February 19, 2015

Re: Silo Ridge Resort Community

STATE OF NEW YORK DEPARTMENT OF TRANSPORTATION
HIGHWAY WORK PERMIT APPLICATION FOR UTILITY WORK

ROADWAY IMPROVEMENT PLANS

Enclosed is an overall site plan highlighting the project modification since the last submission. Two (2) of the most significant changes includes:

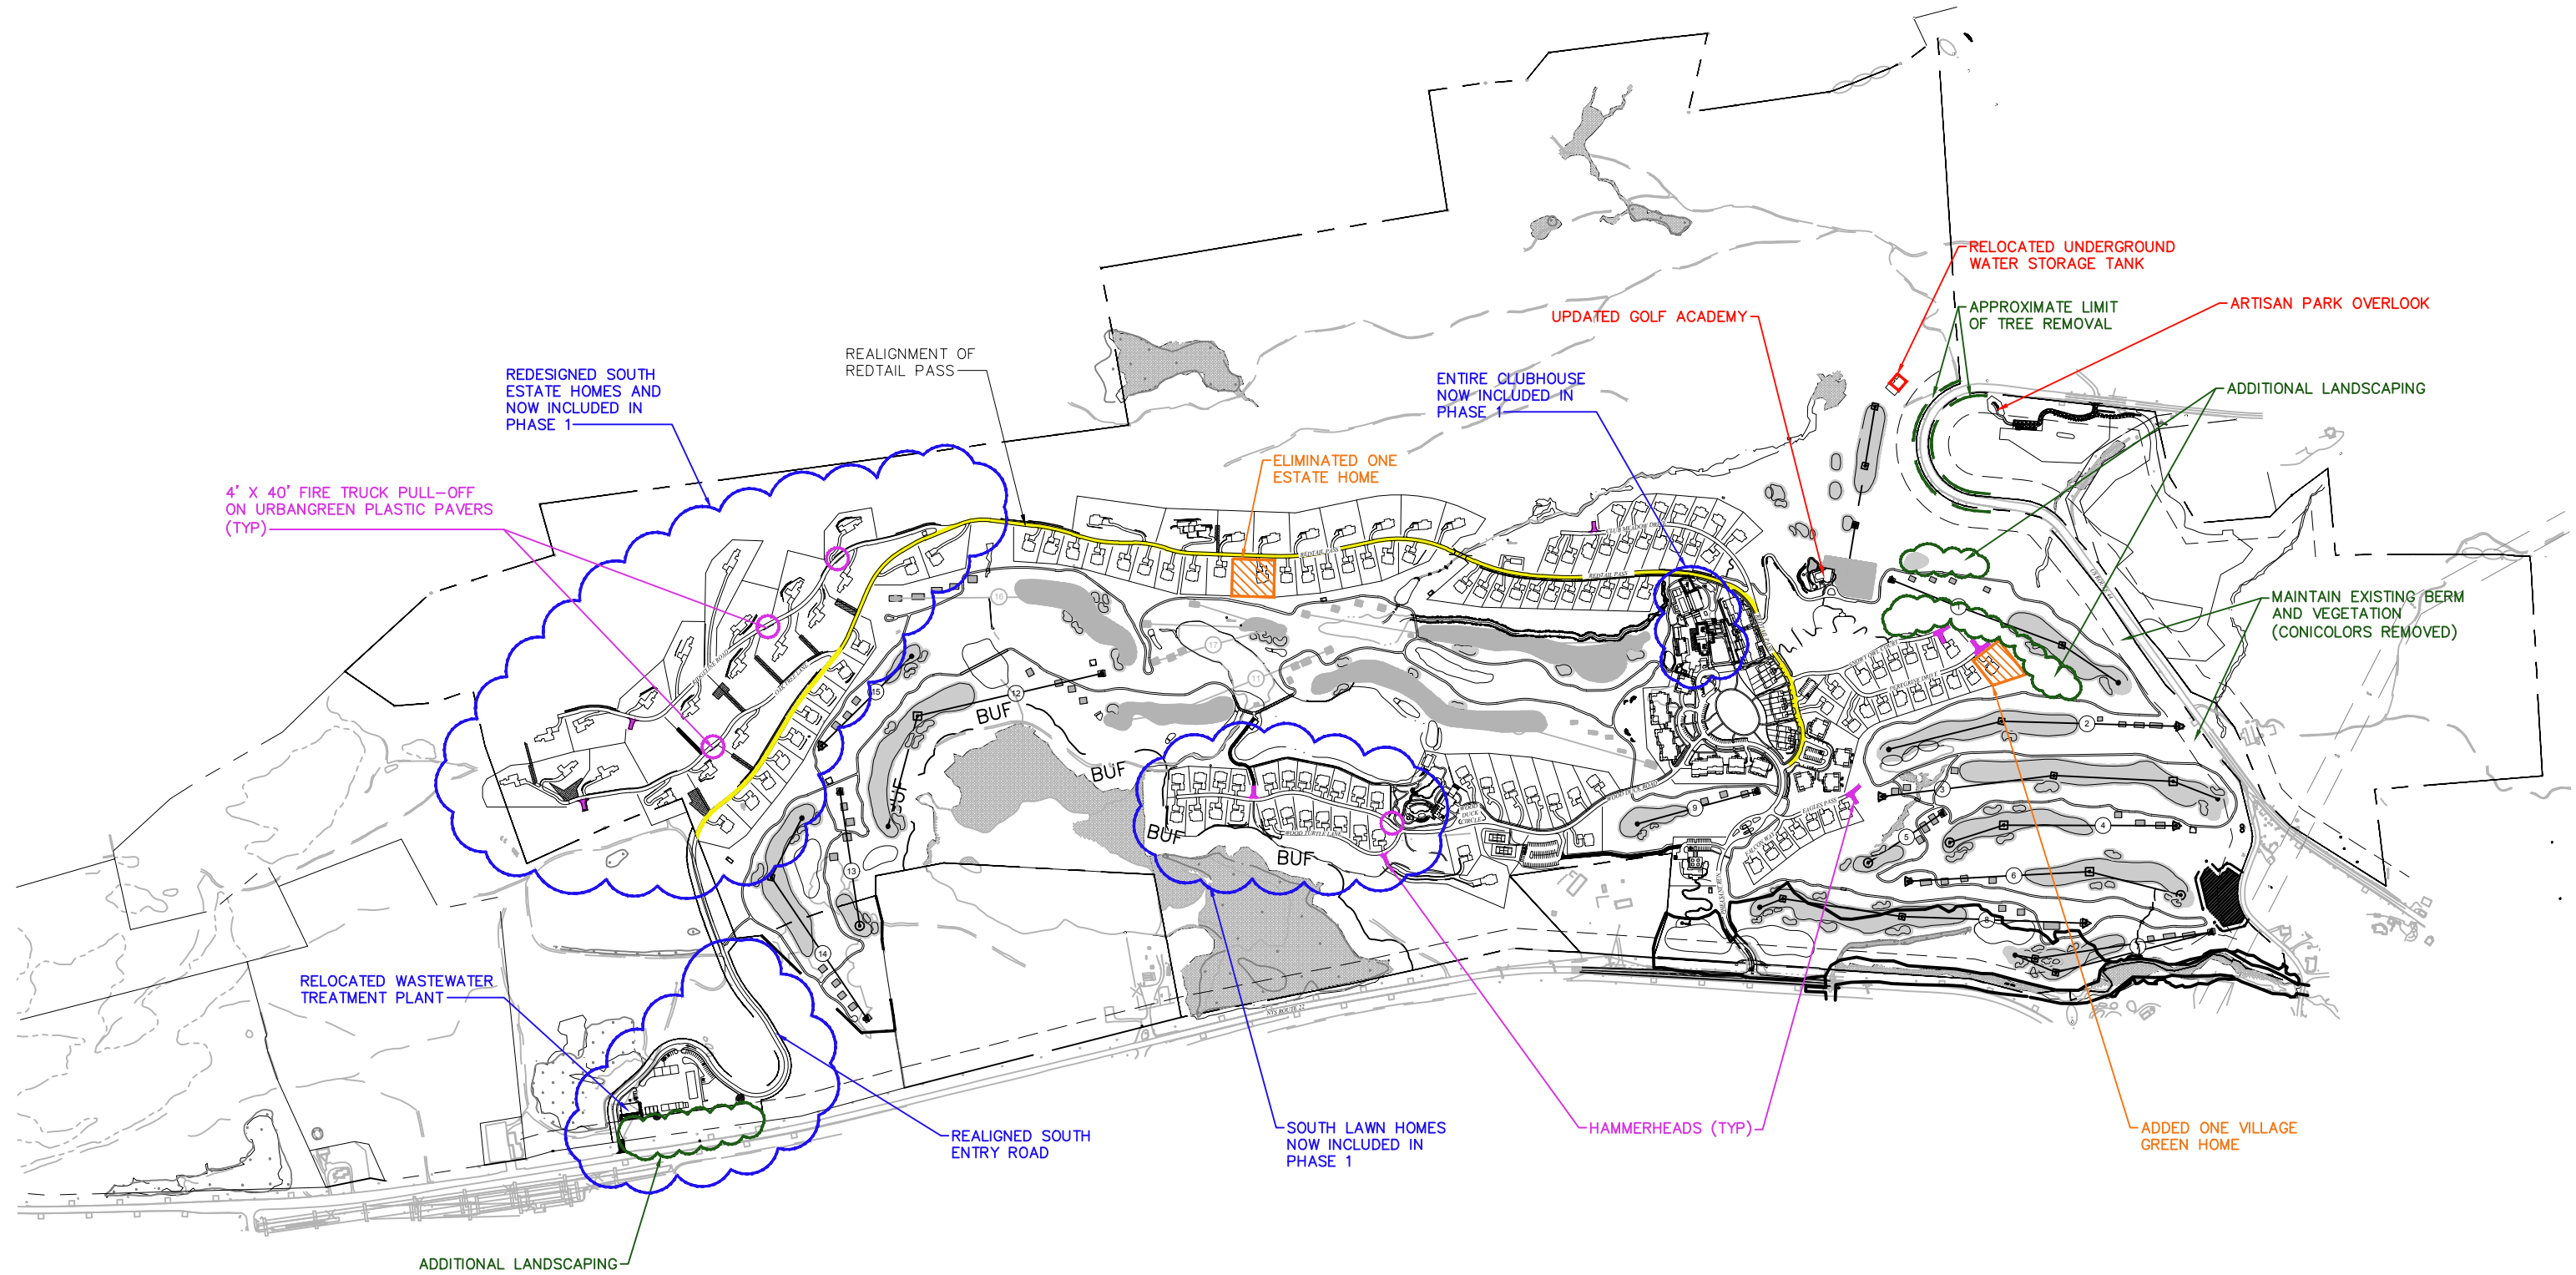
- The wastewater treatment plant ("WWTP") has been relocated to the south to the Golf Maintenance Facility area on the Harlem Valley Landfill Corp. property; and
- The water storage tank has been relocated to the south side of Route 44 and just west of the driving range;
